Revision B This document supersedes previous revisions.

SWAY BAR CLAMP HARDWARE REPLACEMENT

Prevost vehicles

On the vehicles affected by this bulletin, replace the hardware on the sway bar clamps of the steer and drive axles.

Figure 1

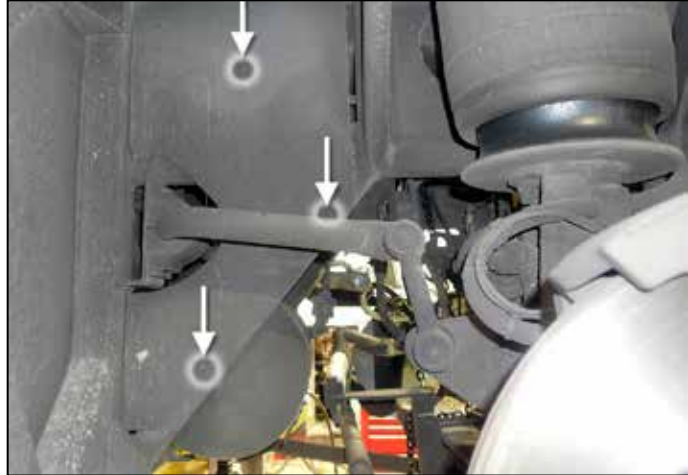
1. Create some working room by removing splash guards on both sides of the front axle.

Figure 3

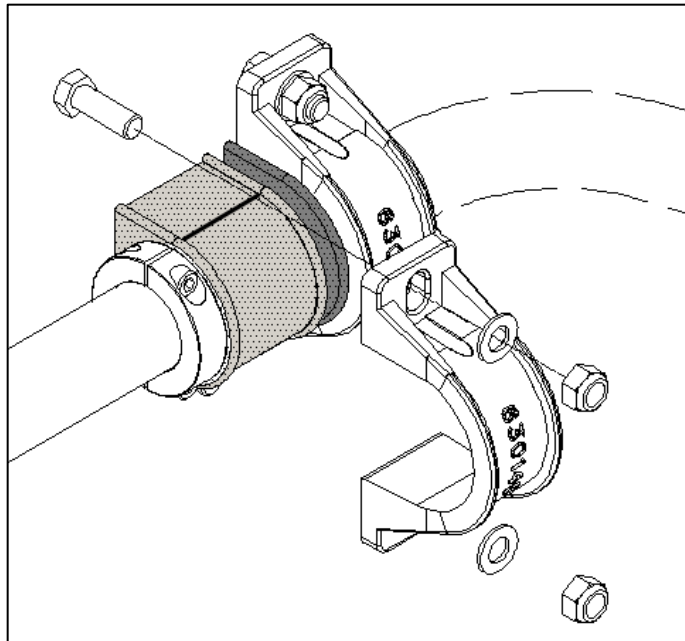
Replace with new bolts, nuts and washers one at a time. (fig. 3)

Confirm proper washer orientation before tightening. See fig. 4.

Tighten bolts two times.

1st: **50lbf-ft**

2nd: **90lbf-ft**

Tighten bolts in the following sequence:

- **Lower** bolt
- **Upper** bolt
- **Lower** bolt
- **Upper** bolt
